Access Compliance Report

Public Rights-of-Way

(Pedestrian Signals)

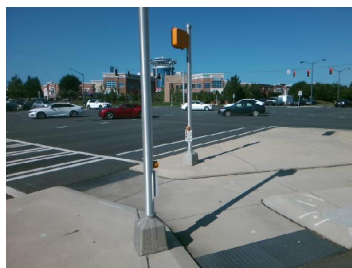
PROW/ADA: R404.2, R404.3, R406.2, R404.7.3

Possible Solutions: Provide Push Button Extension. Remove and Replace Clear Space.
